Service Bulletin

Subject: RM100/125 LEFT CRANKSHAFT MAIN
BEARING

Bulletin No: RM-27
Date: July 2, 1976
Read and Initial
Manager _____
Parts _____
Service MP

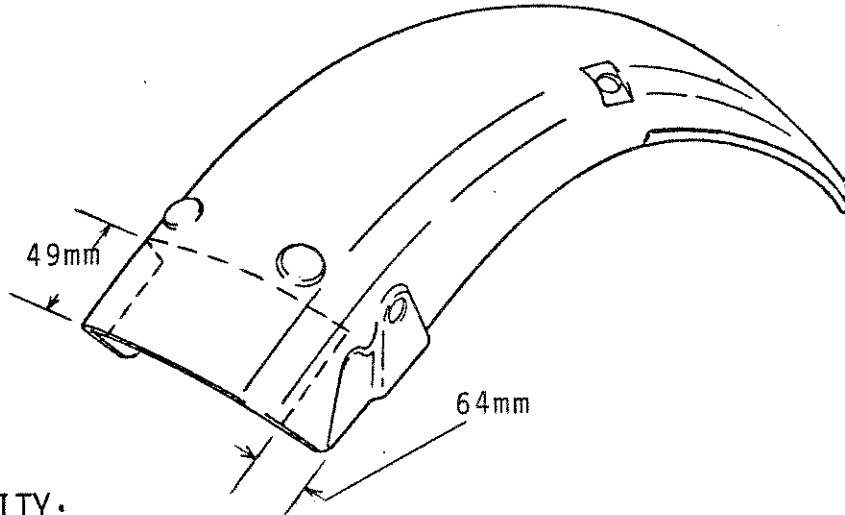
NOTICE: To further improve the air cleaner system and ease of maintenance on the RM250 and RM370's, the air cleaner assembly has been changed.

1. The shape of the air cleaner element has been changed to provide a more positive seal.
2. The shape of the air box has been changed to provide easier accessibility to the element.

3. To provide easier installation and removal of the filter element, the fastening device has been changed from a wing nut to a snap pin.
4. The carburetor air inlet hose mounting surface dimensions have been changed for more positive sealing, however, it's overall length remains the same.

1. Due to the differences in dimensions the new and old air cleaner components are not interchangeable, with the exception that the new style fender may be used with an old style air cleaner assembly.
2. When installing a new style air cleaner assembly on a unit equipped with an old style rear fender, the rear fender must be cut as shown below.

Subject: RM370 SECOND DRIVE GEAR

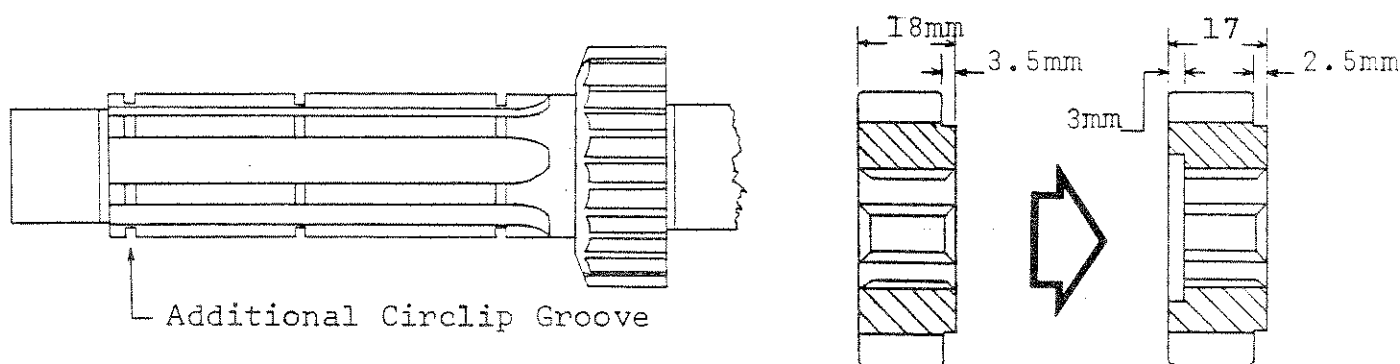
The countershaft and second drive gear have been modified in the manner illustrated below.

When installing circlip on end of shaft all other components must be slide towards 1st gear. Then, position all circlips correctly and reslide everything back towards 2nd drive gear.

Subject: RM250/370 KICK STARTER SHAFT

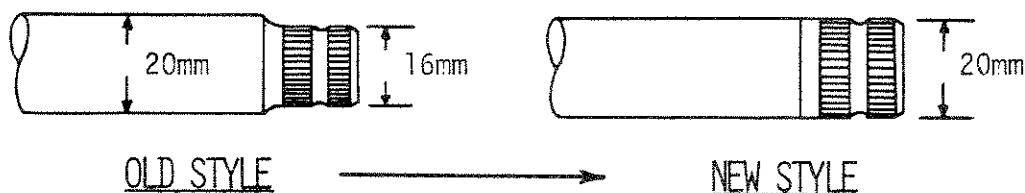
We have received reports of RM250/370 kick starter shafts breaking. To prevent this from happening, the splined end of the kick starter shaft has been increased in size as illustrated below.

Along with the kick starter shaft modification, the kick starter lever has also been modified to accommodate the increased dimensions of the new shaft.

*The new style kick starter shaft can be interchanged with the old style kick starter shaft only if the new kick starter lever is used and vice versa.

MEASURING METHOD:

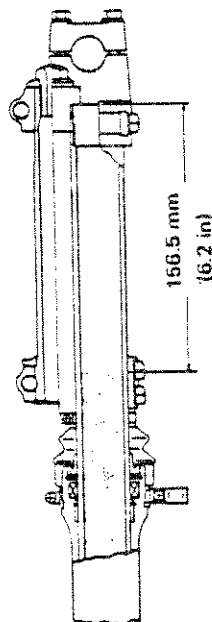
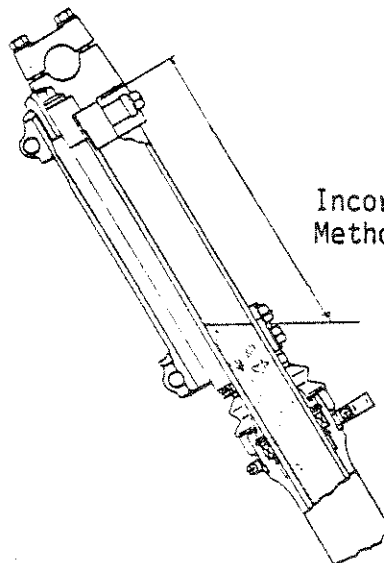
The oil level is then measured from the fork cap seating surface to the actual fluid level. This measurement should be:

NOTE: To achieve maximum suspension performance, the fork oil level must remain within the specified maximum and minimum levels. This measurement is critical and should not be deviated from.

RM250 1st AND 5th
DRIVEN GEARS

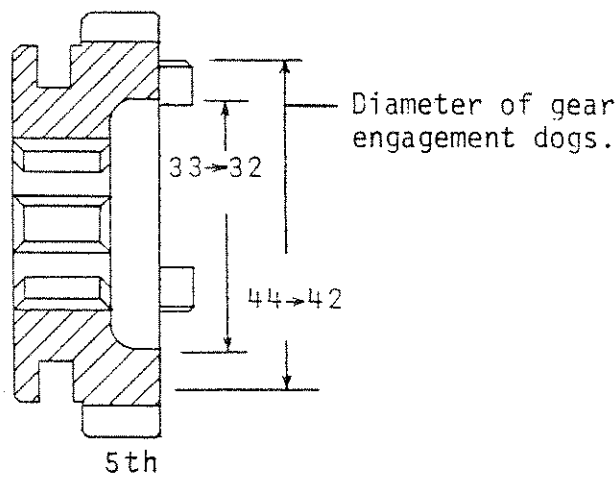
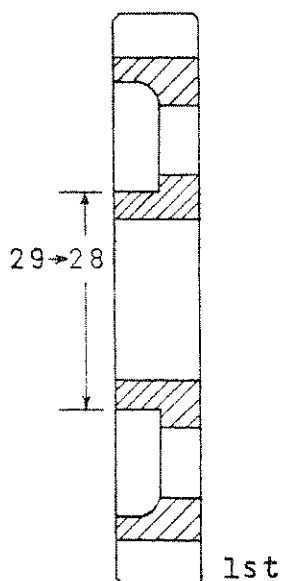
1st and 5th driven gears of the RM250 transmission have been changed to provide added strength and reliability. Although the actual gears ratios remain the same, certain structural dimensions have been changed as illustrated below.

*First and fifth driven gears are interchangeable, but only as a set.

RM250/370
PISTON RING LOCATING PINS

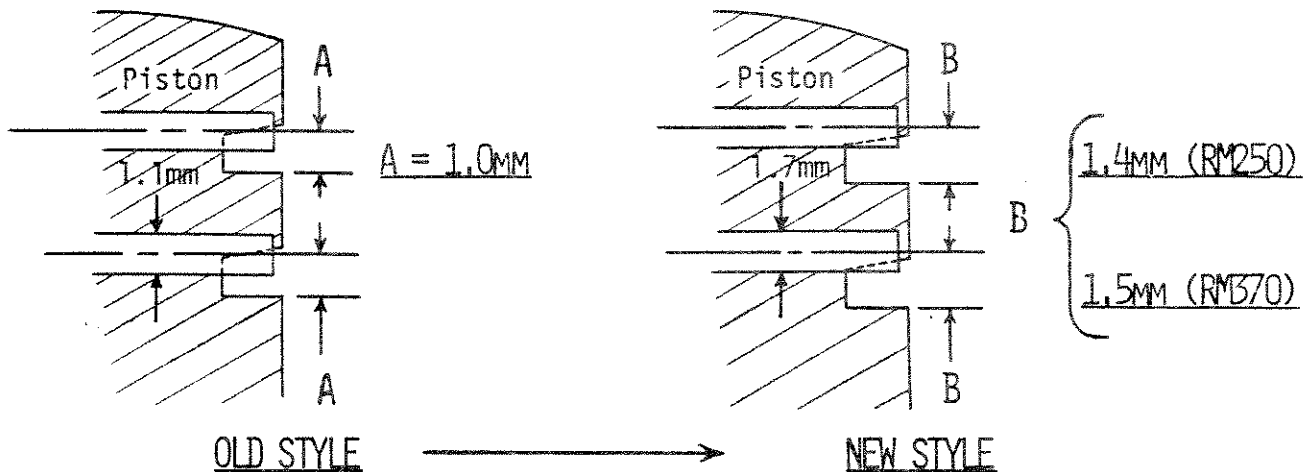
I. To increase their durability, the RM250A and RM370's piston ring locating pins have been changed as indicated below:

- The piston rings' locating pins have been increased in diameter 0.6mm, from 1.1 to 1.7mm.
- At the same time, the locating pin position has been raised 0.4/0.5mm (RM250A/370) further from the bottom of the ring groove.

II. To accomodate the piston ring locating pin changes, the piston ring ends have been changed as illustrated below:

*The old style and new style piston and piston ring set must be interchanged as a set. They are not interchangeable separately.

RM80 GEARSHIFT
PAWL MODIFICATION

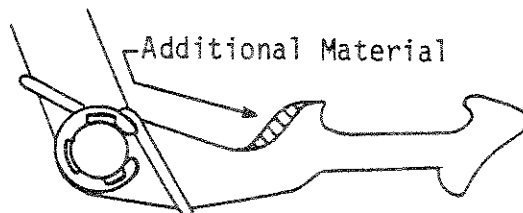
We have had reports of RM80's gear shift lever sticking in the up position, when shifting into higher gears; 3rd, 4th, or 5th. When this happens, the shift drum of the transmission is actually rotating past the normal stopping point, which allows the next shift drum pin (#1 in illustration) in rotation to restrict the shifting pawl's movement back to its original position.

This situation has been cured by the addition of a small amount of material applied to the gear shift pawl, which restricts the shift drum from rotating too far.
